Subject: Serial 2731 8-27-01 Version 1b

Subject: Response to NRC Bulletin 2001-01, "Circumferential Cracking of Reactor Pressure Vessel Head Penetration Nozzles"

RESPONSE TO
NRC BULLETIN 2001-01

DAVIS-BESSE NUCLEAR POWER STATION

Figure 1

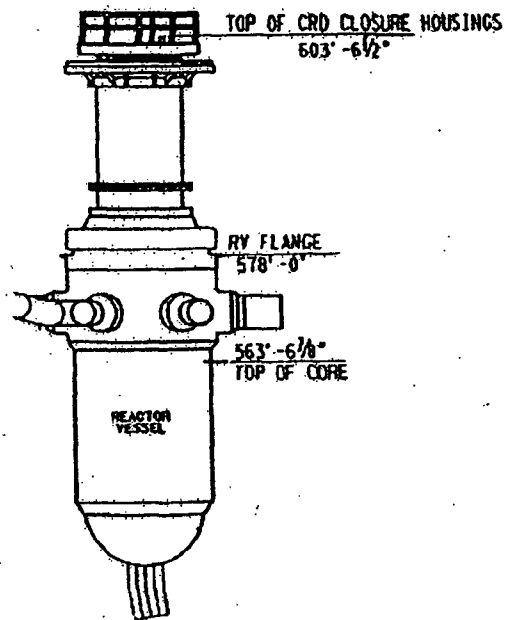
A description of the configuration of the missile shield, the CRDM housings and their support/restraint system, and all components, structures, and cabling from the top of the RPV head up to the missile shield. Include the elevations of these items relative to the bottom of the missile shield.

The elevations for the Reactor Coolant System (RCS), including the top of the CRD Closure Housings at the top of the service structure, are shown in the attached Figure 1. The top of the missile shield over the service structure is at elevation 653'0". The missile shield is comprised of 6 concrete removable panels, each 31' 5" x 6' 6" x 3'. It spans across the refueling canal and is supported on both sides by the Steam Generator "D-Ring" walls.

Figure 2, CRDM Inspection Plan Flow Chart

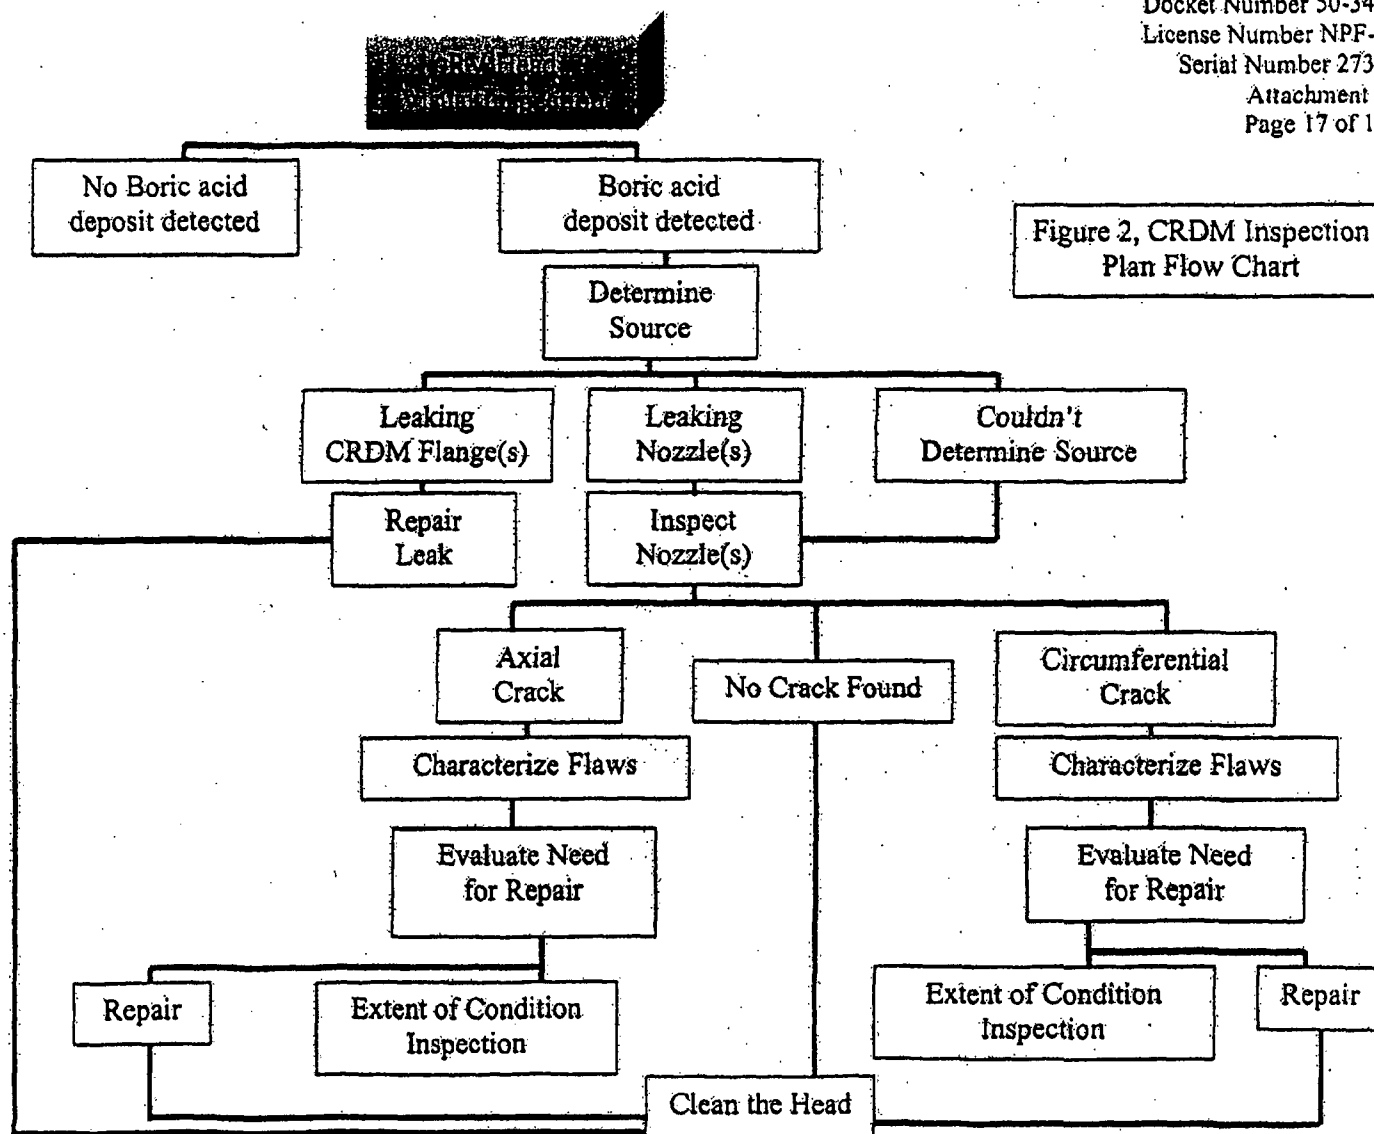
- a. your plans for future inspections (type, scope, qualification requirements, and acceptance criteria) and the schedule;

The acceptance criteria to be used will consist of comparative evaluations of any as-found boric acid crystal deposits to photographs of leaking CRDM nozzles observed at ONS3 and Arkansas Nuclear One-Unit 1 (ANO-1) and evaluation against any identified leaking CRDM nozzle flanges. It is currently planned that if the leak is characterized by supplemental inspection as a circumferential crack above the CRDM nozzle weld, the supplemental examination will be expanded to additional CRDM nozzles, not to exceed 10%. Additionally, it is planned that if, during the additional supplemental examinations, any circumferential crack is identified above the weld which is not through-wall (has not caused a nozzle leak), the supplemental examinations will be expanded to 100% of the CRDM nozzles. A flow chart of the inspection plan is shown in Figure 2. Details of the inspection plan will be developed prior to the 13RFO.

Figure 3

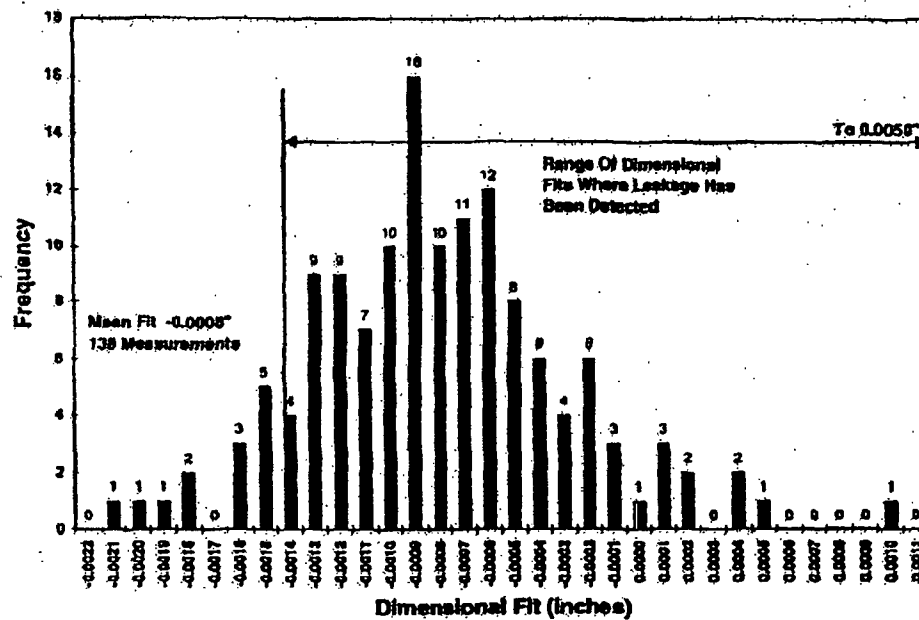
- (1) If your future inspection plans do not include performing inspections before December 31, 2001, provide your basis for concluding that the regulatory requirements discussed in the Applicable Regulatory Requirements section will continue to be met until the inspections are performed.
- (2) If your future inspection plans include only visual inspections, discuss the corrective actions that will be taken, including alternative inspection methods (for example, volumetric examination), if leakage is detected.

As noted earlier, leakage from this gap has been demonstrated at both ONS and ANO-1, for which interference fits of up to 0.0014 inches have been calculated from the final QA inspection data (as documented in MRP-44, Part 2). Figure 3 provides a graphical representation of these data. The largest interference fit at the DBNPS occurs on nozzle number 50 which, as stated previously, has been calculated at 0.0021 inches at the top. This same nozzle also has an interference fit of 0.0010 inches at the bottom. Thus, the 0.0033 inch gap during operation would be somewhat less for the DBNPS, assuming the 0.0021 inch interference fit (instead of the nominal 0.001-inch). This gap would still be expected to provide a leak path to the top of the

▪ Nozzle Arrangement – 69 CRDM Nozzles

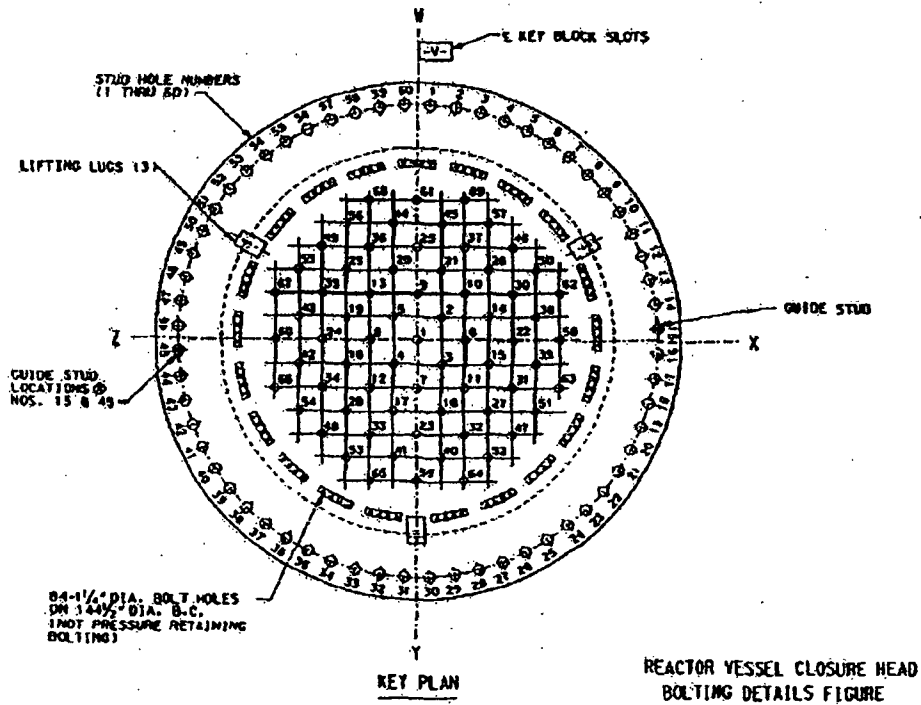
A description of the VHP nozzles in your plant(s), including the number, type, inside and outside diameter, materials of construction, and the minimum distance between VHP nozzles

The DBNPS has 69 Control Rod Drive Mechanism (CRDM) nozzles of which 61 are used for CRDMs, 7 are spare, and one is used for the Reactor Pressure Vessel (RPV) head vent. Each CRDM nozzle is constructed of Inconel Alloy 600 and is attached to the RPV head by an Inconel Alloy 182 J-groove weld. The RPV head is constructed of carbon steel and is internally clad with stainless steel. The material for the nozzles was supplied by two suppliers. B&W Tubular Products supplied material for 60 nozzles and Huntington Alloys supplied the material for the remaining 9 nozzles. The head arrangement and requested nozzle details are provided in Attachment 2.
